APPLICATION FOR SITE PLAN REVIEW

TO THE CITY OF PORTSMOUTH
FOR 1151 SAGAMORE AVENUE

Re: Request for Site Plan Review at 1151 Sagamore Avenue, Tax Map 224, Lot 19

TAC Comments

N 5010314.002

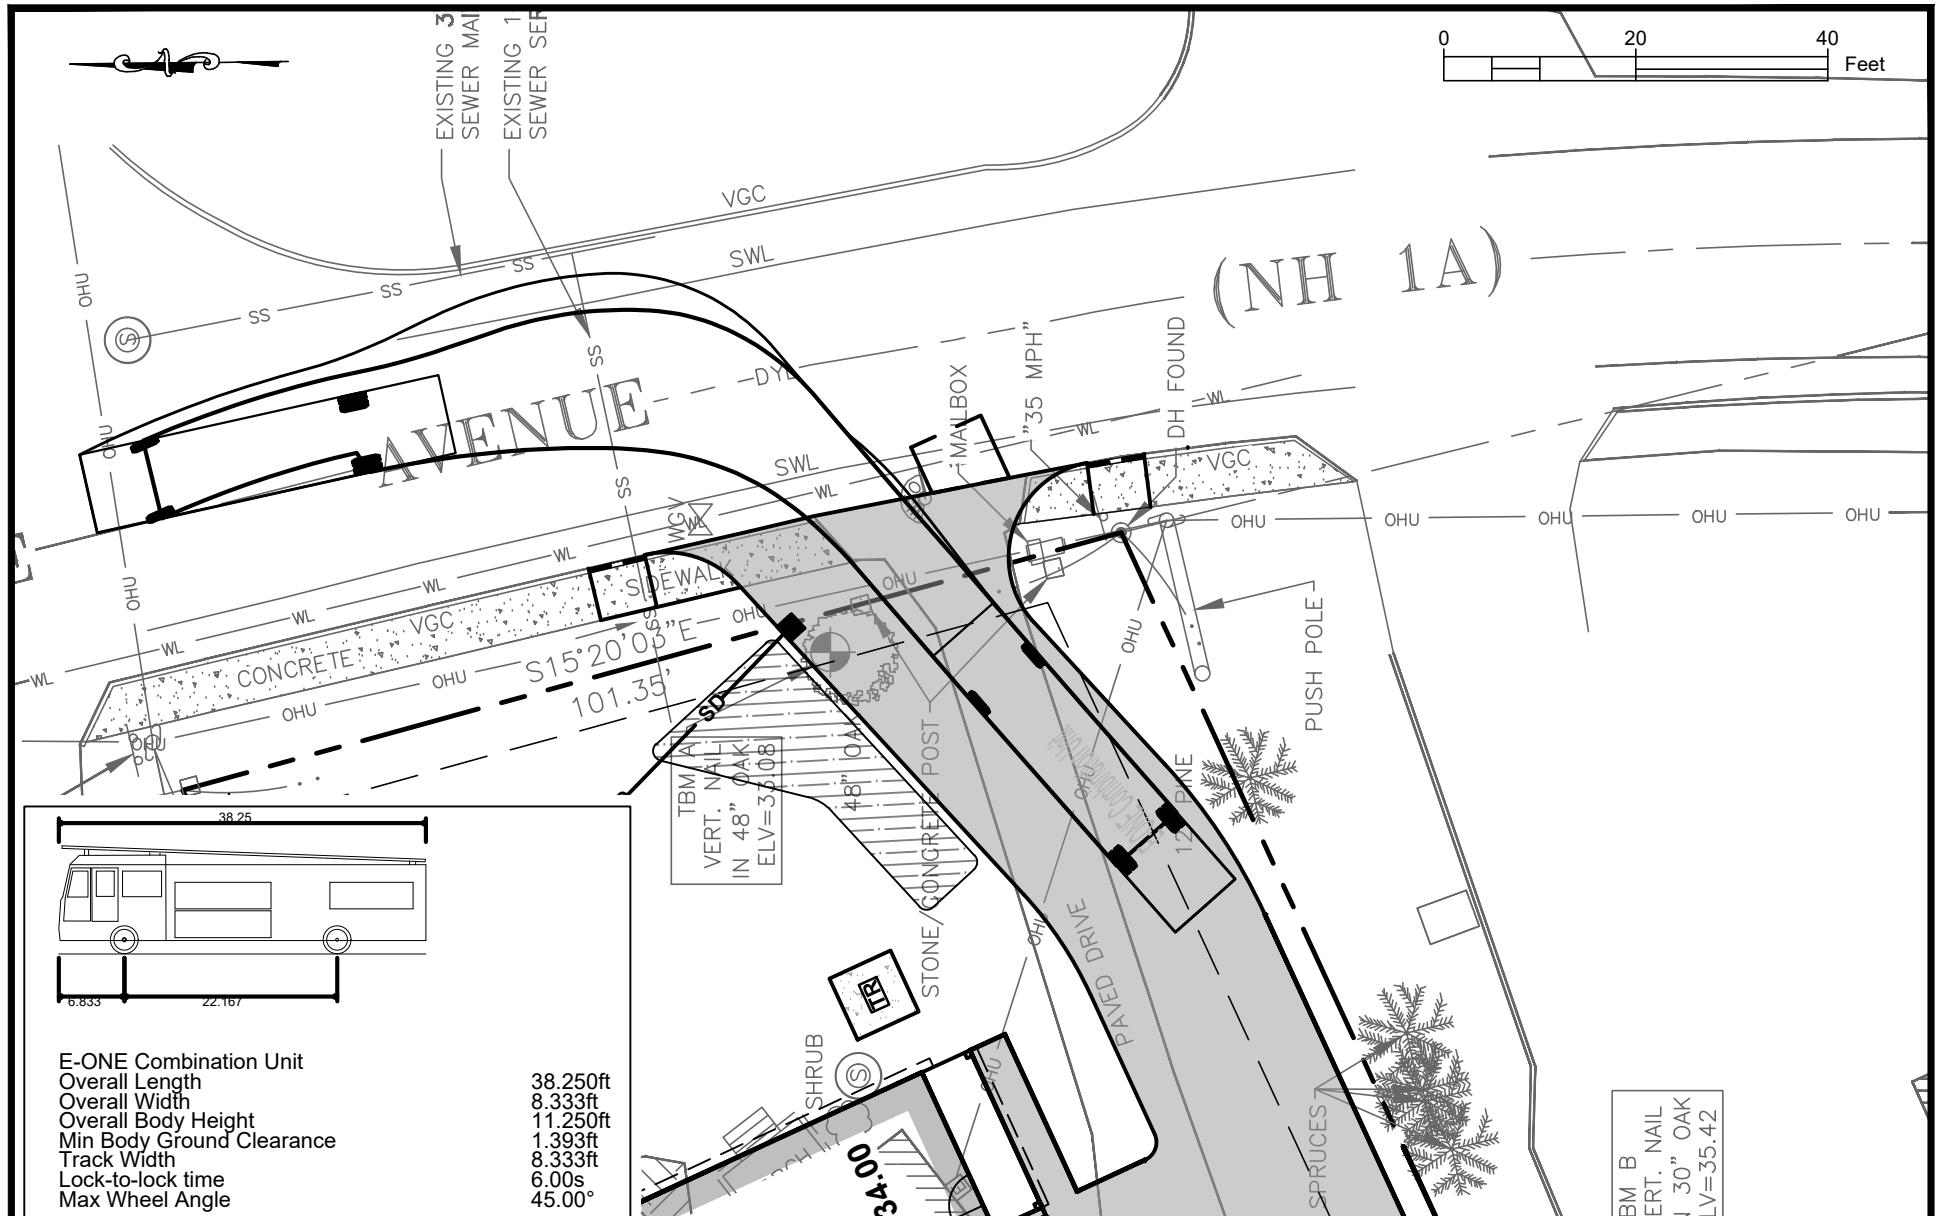
4. South side of the driveway does not need radius. Remove radius and continue straight line of driveway until it intersects with Sagamore Ave.

HW Response: The driveway entrance was originally located further south but was shifted north at the direction of NHDOT. This radius is necessary to accommodate emergency vehicle accessing the site from north-bound Sagamore Ave as shown on the turning movement diagrams included within the drawing set.
